**APPROACH TO RESOLVING  
RAI LETTERS 77 AND 79**

**Fermi 3 COLA**

**November 29, 2012**

Figure 03.07.02-6(13)a Lateral Soil Pressure - RB/FB R1 Wall – Case RFB

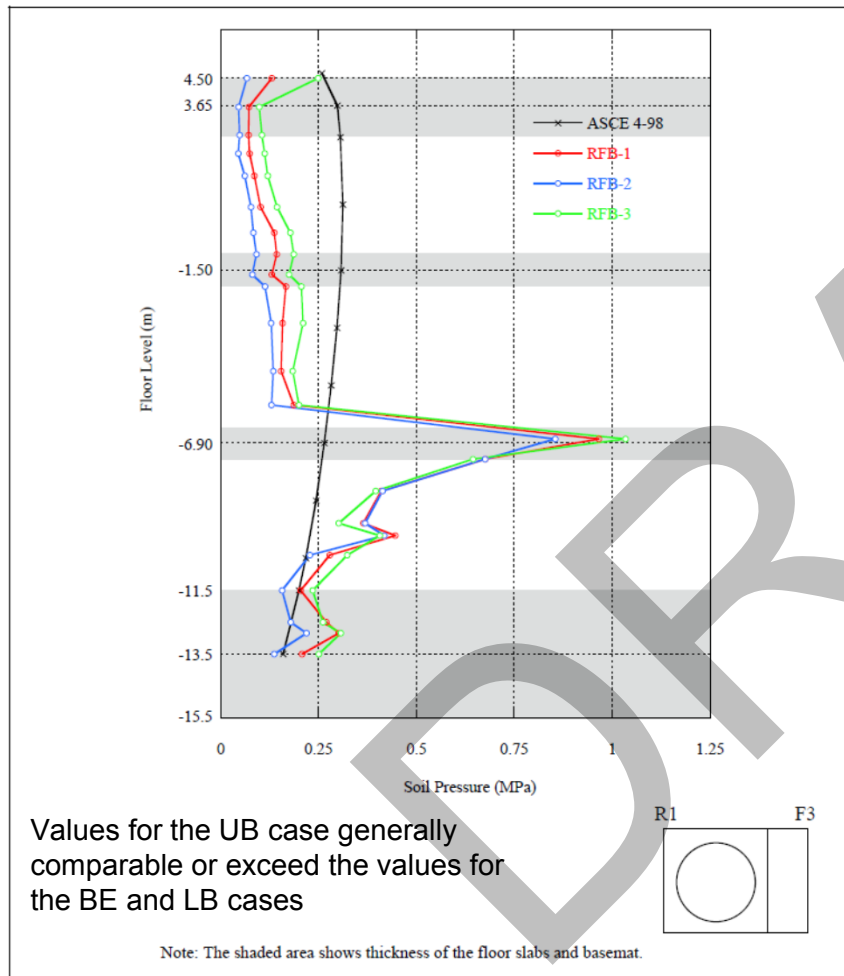
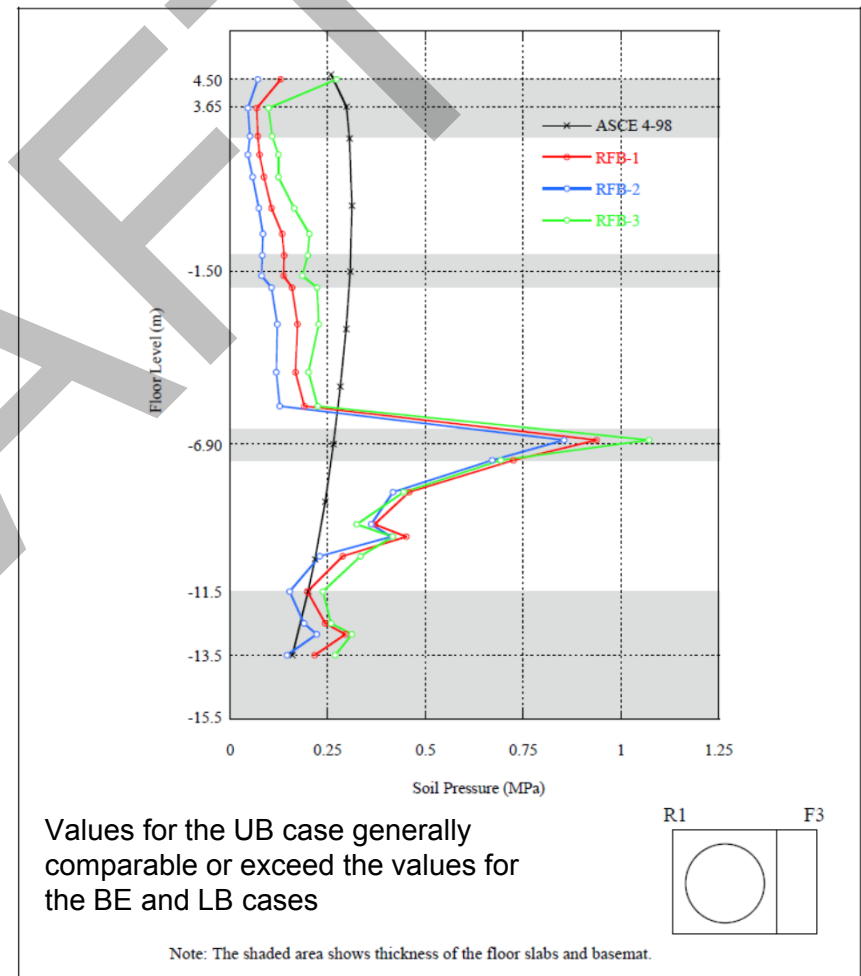
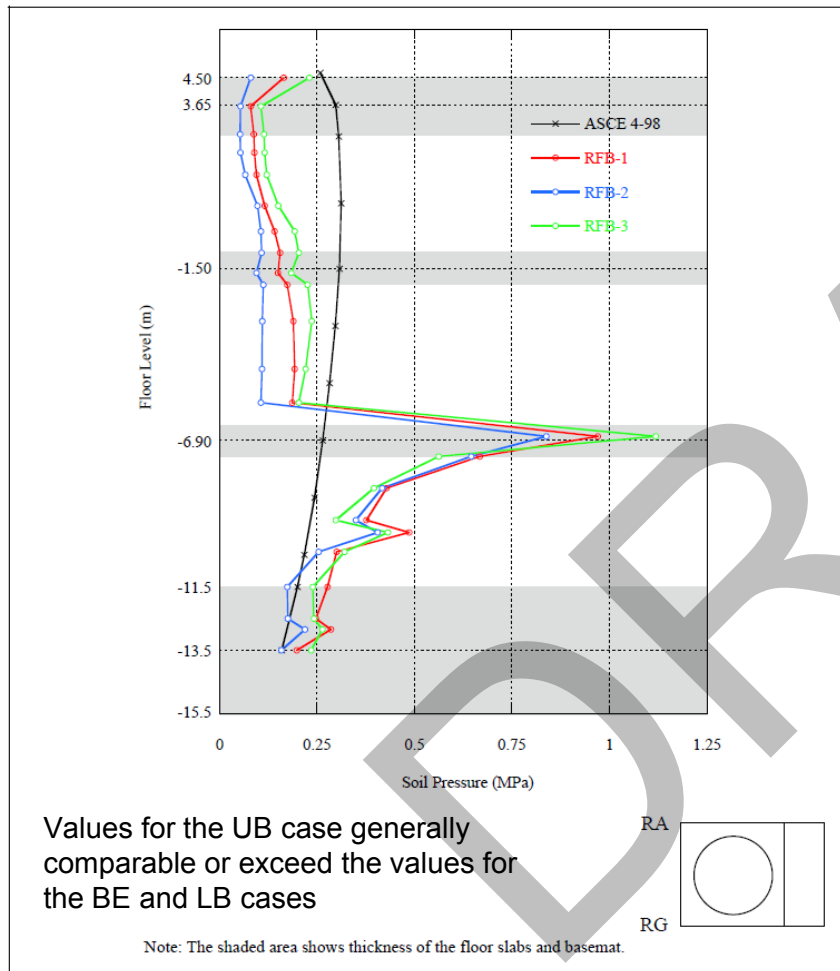
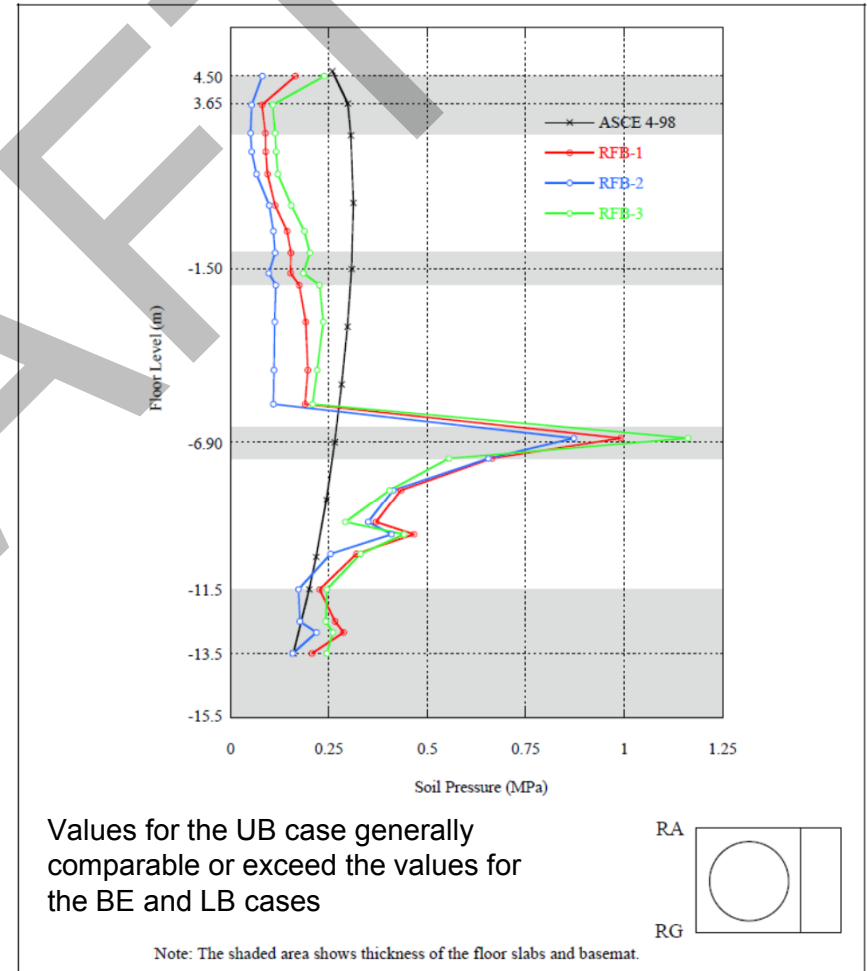
- Previous studies (SER-DTF-008, Rev.1) have shown that for the regions where the lateral wall pressures are not enveloped by the ASCE 4-98 curve, the lateral wall pressure values for the UB case generally equal or exceed the values for the BE and LB cases; in the limited number of cases where the UB case does not control, the values are comparable

- Wall pressure diagrams from SER-DTF-008, Rev.1 are shown on the following slides (note that UB is the green curve)

Figure 03.07.02-6(14)a Lateral Soil Pressure - CB C1 Wall – Case CFB1

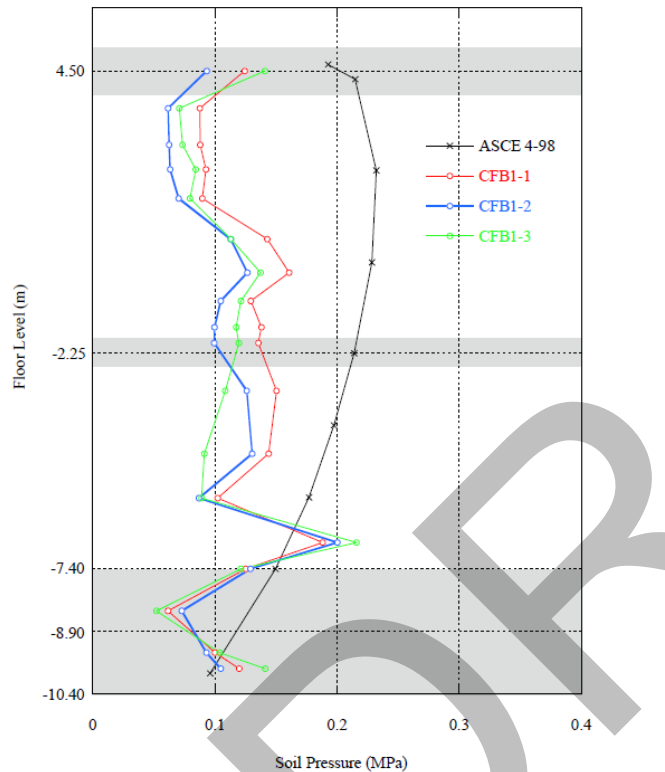
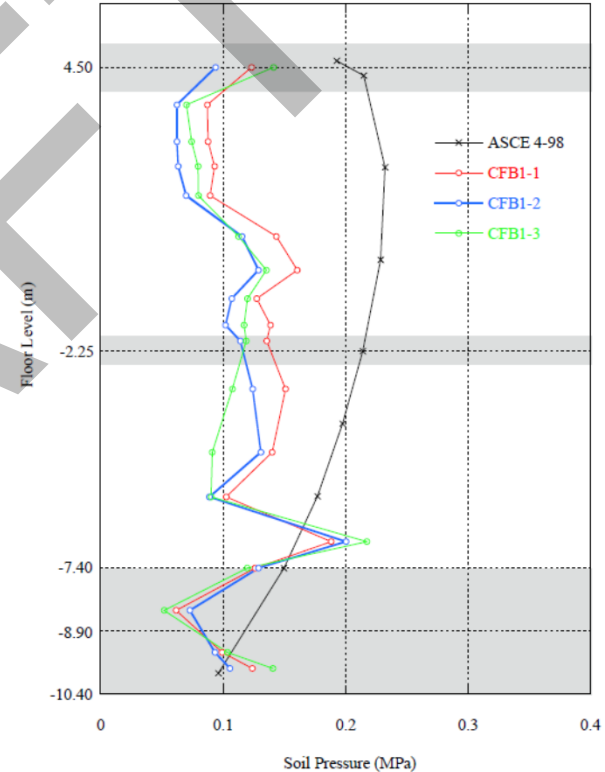
Where values exceed the ASCE 4-98 values, values for the UB case generally exceed the values for the BE and LB cases

Where values exceed the ASCE 4-98 values, values for the UB case generally exceed the values for the BE and LB cases

Figure 03.07.02-6(14)c Lateral Soil Pressure - CB CA Wall – Case CFB1

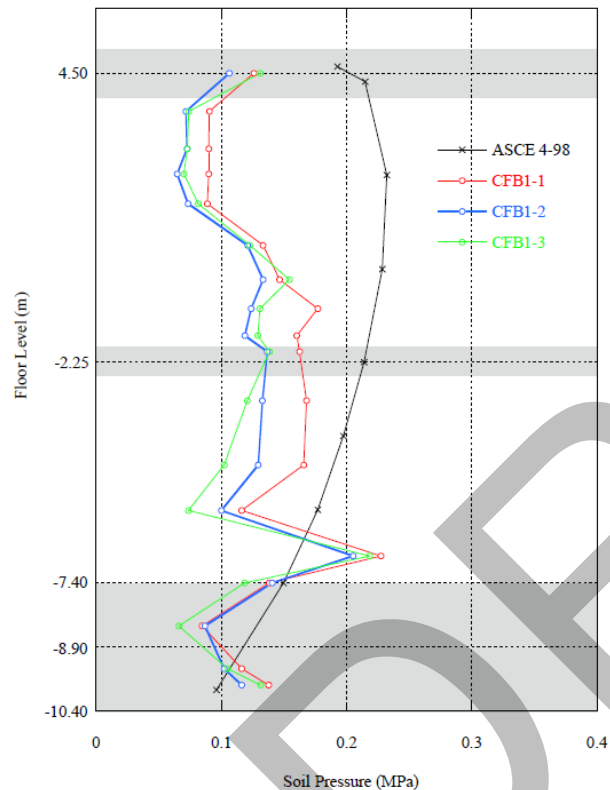
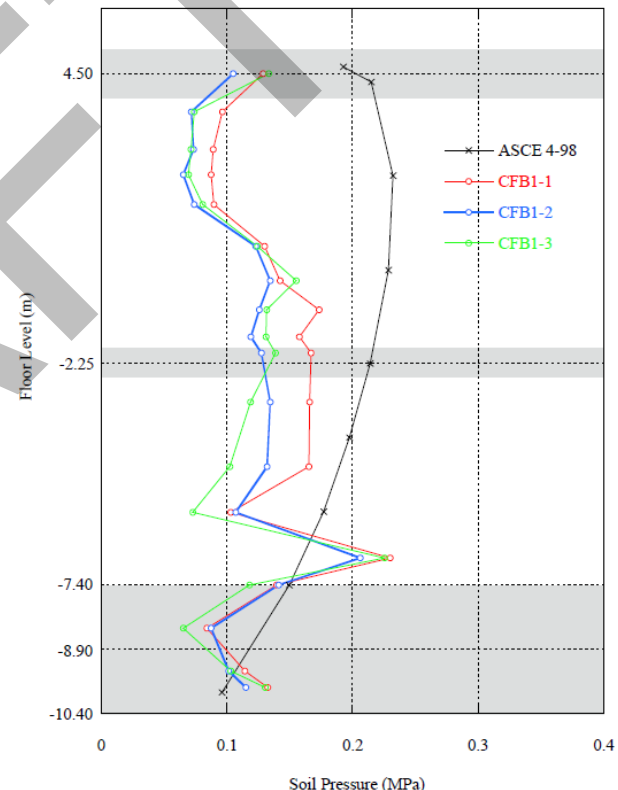
Where values exceed the ASCE 4-98 values, values for the UB case are comparable to the values for the BE and LB cases

Where values exceed the ASCE 4-98 values, values for the UB case are comparable to the values for the BE and LB cases
